CR154 – Panigale V4 Side Stand Update
Models: Panigale V4 2018 (all model versions)
Technical Service Bulletin SRV-TSB-18-009

Date: Thursday, May 11th, 2018

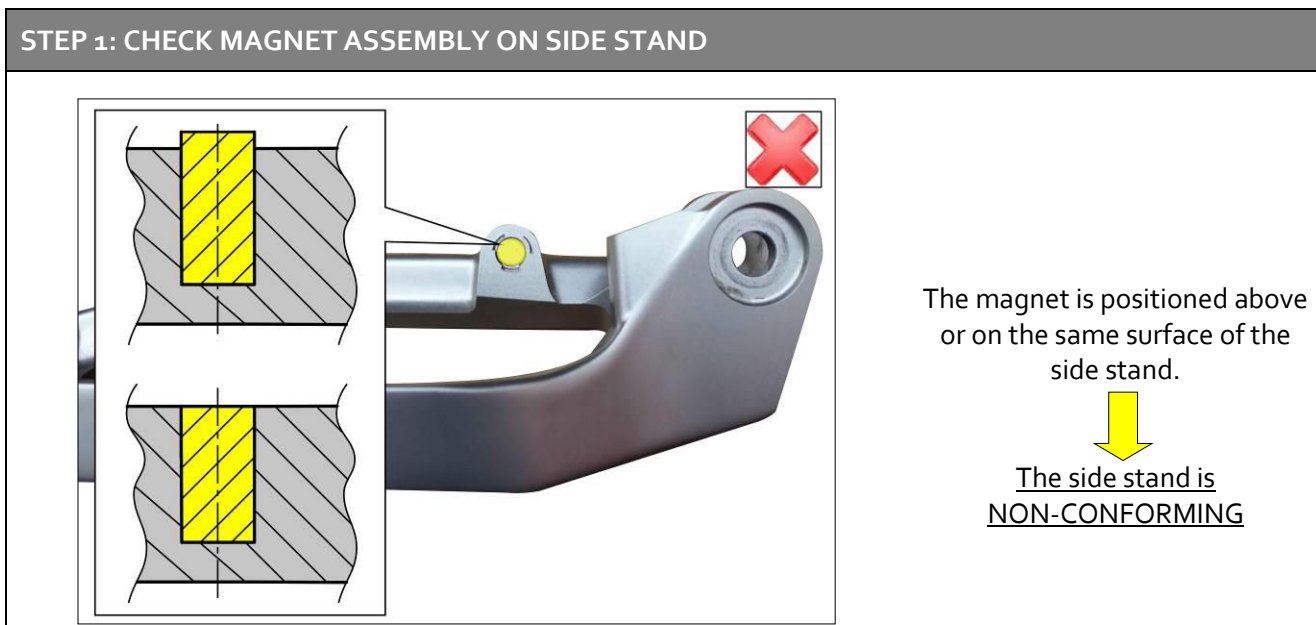
As a result of ongoing product tests and the analysis of feedback from the field, we have detected a potential issue concerning the side stand sensor for the above-indicated motorcycles. Due to production compliance issue, the magnet could have been incorrectly installed inside the seat on stand, affecting the correct operation of side stand sensor. On all involved motorcycles it is necessary to remove the side stand and then visually check the magnet:

- 1) If the magnet is positioned below the side stand surface, this stand is COMPLIANT, and the caulked areas must then be clinched with a flat tipped punch to ensure magnet remain in position:

- 2) If the magnet is positioned above or on the same surface of the side stand, this stand is NOT COMPLIANT and must be replaced.

STEP 1: CHECK MAGNET ASSEMBLY ON SIDE STAND	
	<p>Magnet upper surface is positioned lower than the side stand surface</p> <p>↓</p> <p><u>The side stand is COMPLIANT</u></p>
STEP 2: CLINCH THE CAULKED AREAS	
	<p>Use a flat tipped punch to clinch the caulked areas, with a 120° angle offset in order to ensure retention of the magnet</p>

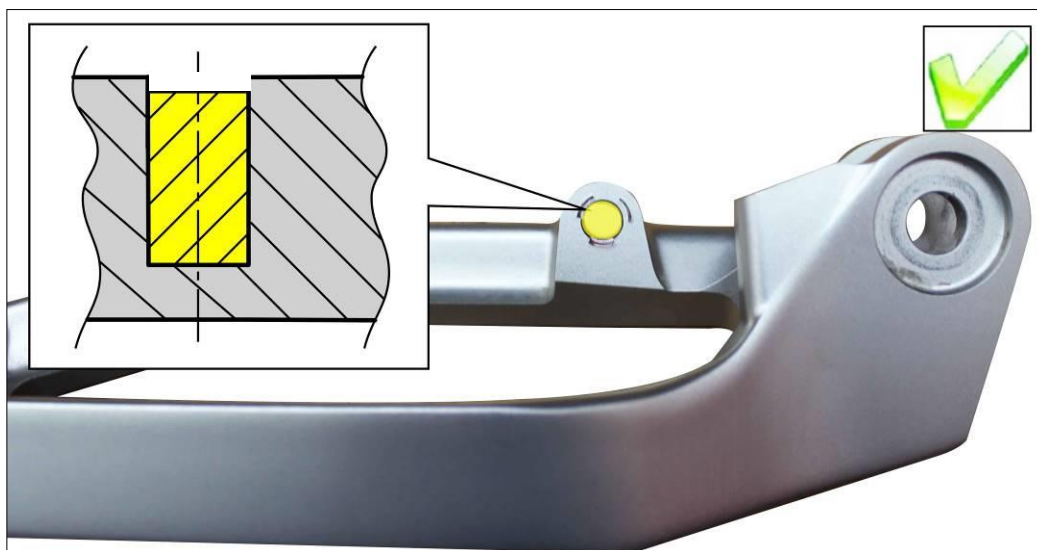
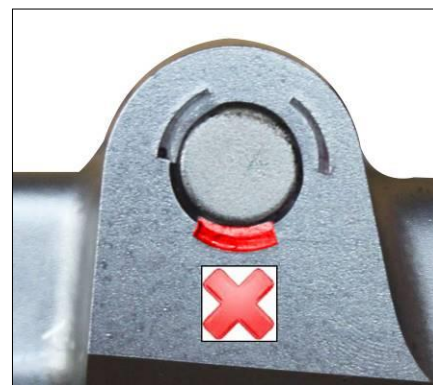
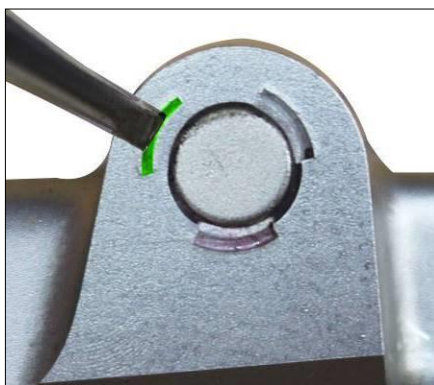
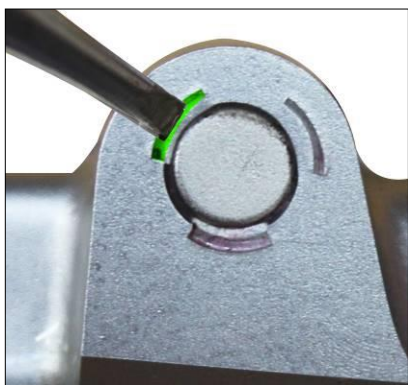
- 4) Position **side stand (3)** on a clean surface and check side stand sensor magnet position:
- a) If magnet upper surface is positioned under side stand surface, the side stand is COMPLIANT.

Using a flat-head tip, clinch the caulked areas with a 120° angle offset, taking care not to damage the magnet.

The caulked areas present close to the magnet, as shown in the figure or the right, must NOT be clinched in order to avoid possible damage to the magnet.

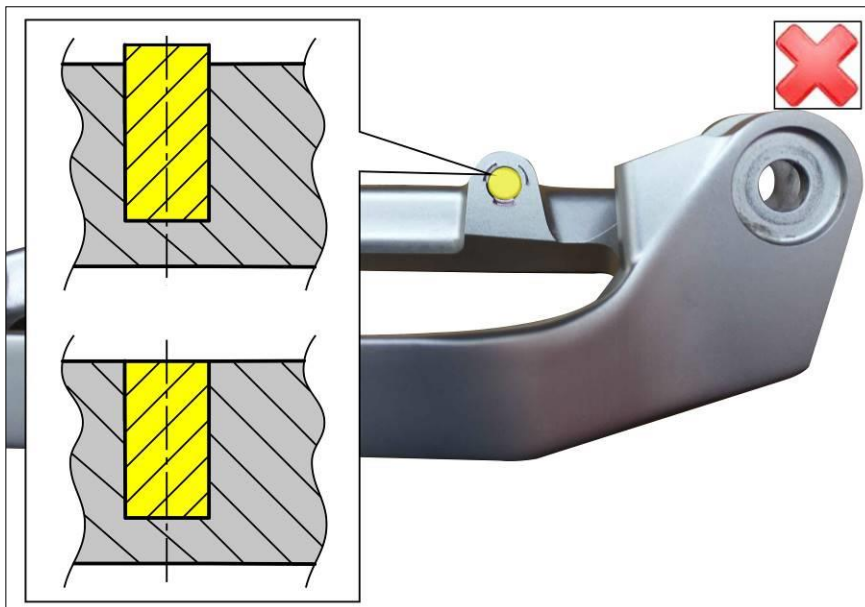
- b) If the magnet is positioned above or on the same surface of the side stand, this latter is NOT COMPLIANT and must be replaced.
